# United States Department of the Interior

9043.1  
ER 15/0430

Re: Review of Notice of Application Ready for Filing (Amendment of License) for the Crown Mill Hydroelectric Project; FERC No. 11175-025, Hennepin County, Minnesota (ER 15/0430)

Figure 28: Proposed Portage Routes

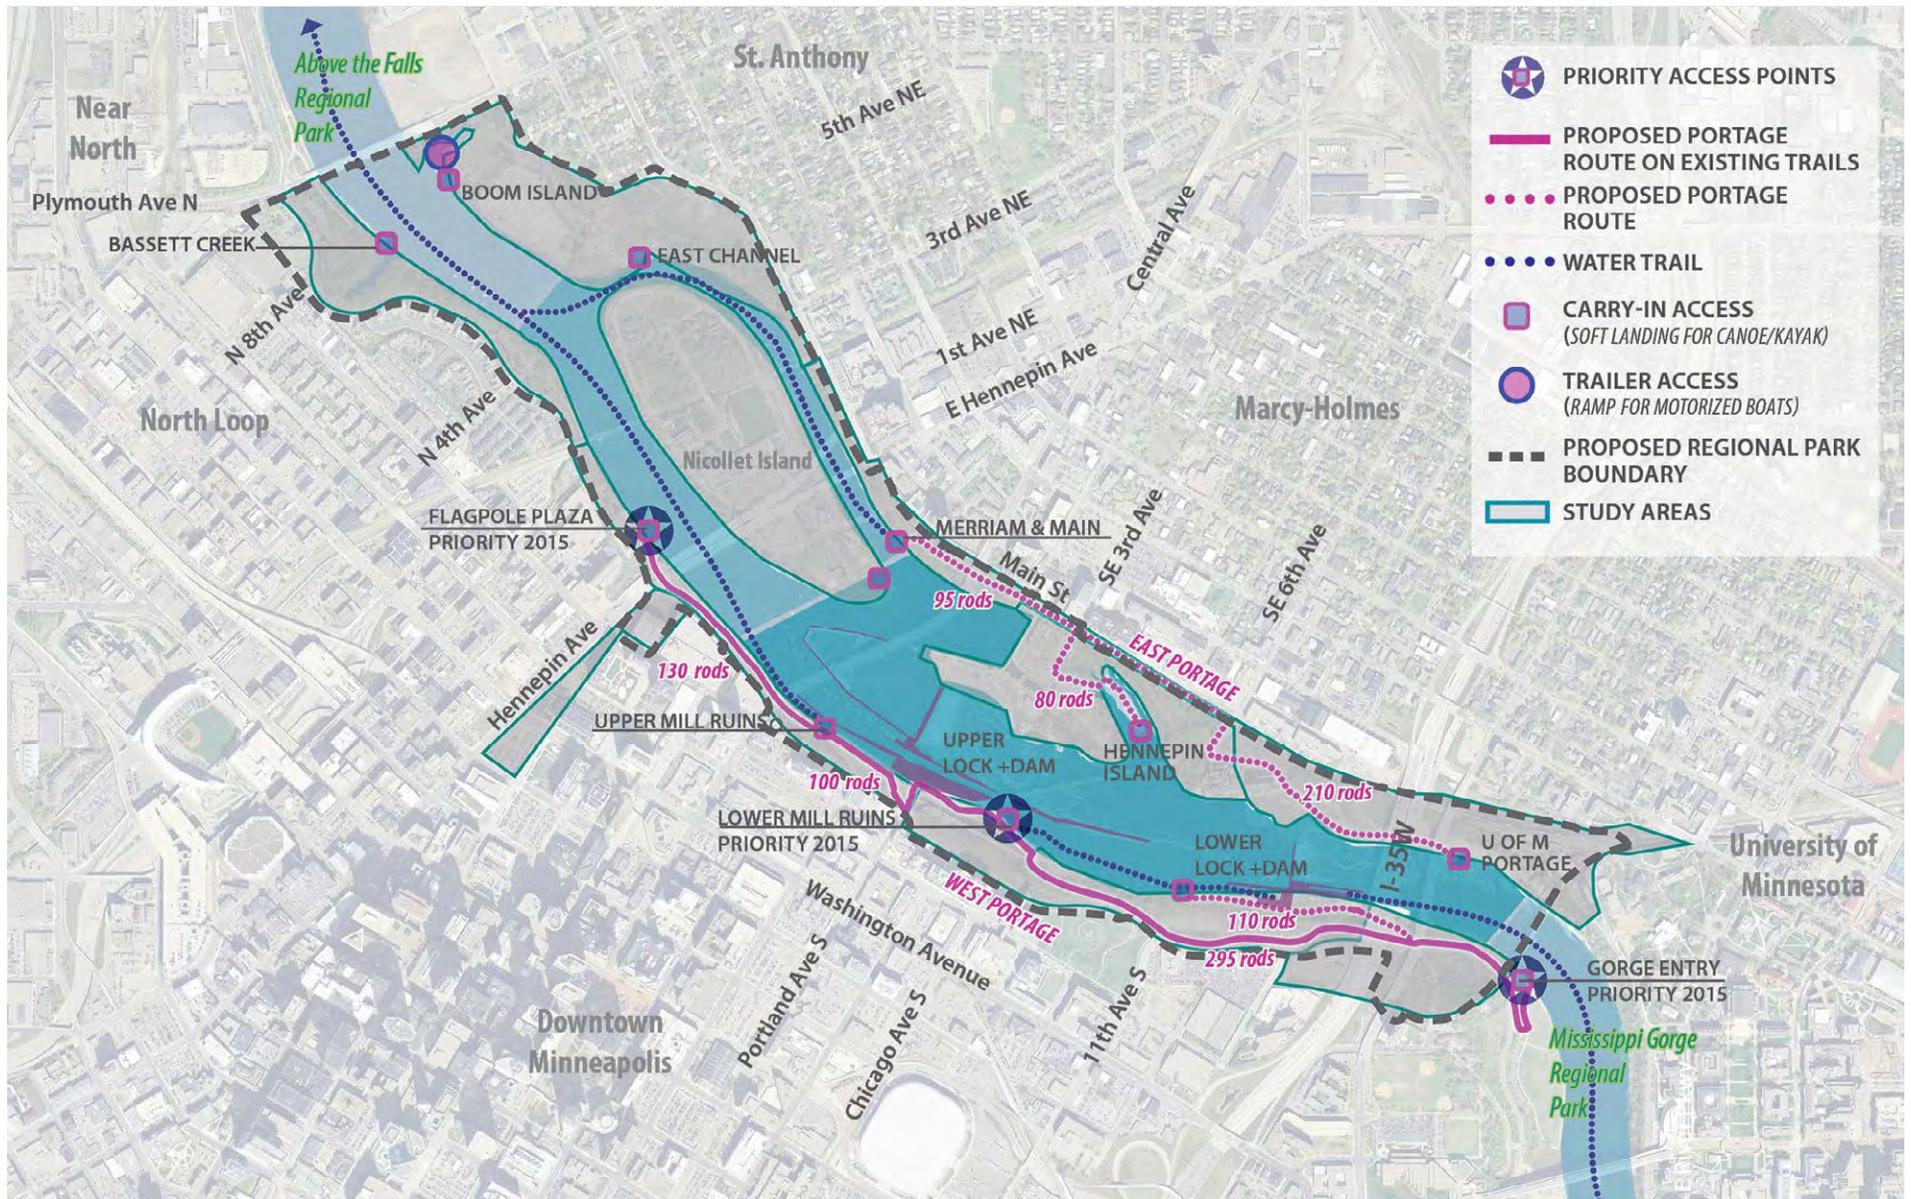
Page 2 -4 – Recreational Resources – The NPS appreciates the Applicant's commitment to working with all interested parties and resource agencies to establish a safe portage route in or near the project area. The proposed Project will impact the put-in location in lower Mill Ruins Park identified in the St. Anthony Falls Regional Park Master Plan and supported by many agencies, as a priority for 2015. The put-in location is exactly where the outfall location would be. Mitigation and continued consultation with all parties will, therefore, be necessary to address the impacts to recreational access in the project area. Figure 28 in the St. Anthony Falls Regional Park Master Plan identifies proposed portage routes including put-in and takeout locations (Enclosure 2). The MPRB submitted a letter on April 20, 2015 detailing their comments on the Project (Enclosure 3). Also see the St. Anthony Falls Regional Park Master Plan (<https://www.minneapolisparcs.org/asset/kff8kx/stanthony-falls-regional-master-plan-3-4-2015.pdf>), and the Central Mississippi Riverfront Regional Park Master Plan ([https://www.minneapolisparcs.org/park\\_care\\_improvements/park\\_projects/current\\_projects/central\\_mississippi\\_riverfront\\_regional\\_park\\_master\\_plan/](https://www.minneapolisparcs.org/park_care_improvements/park_projects/current_projects/central_mississippi_riverfront_regional_park_master_plan/)).
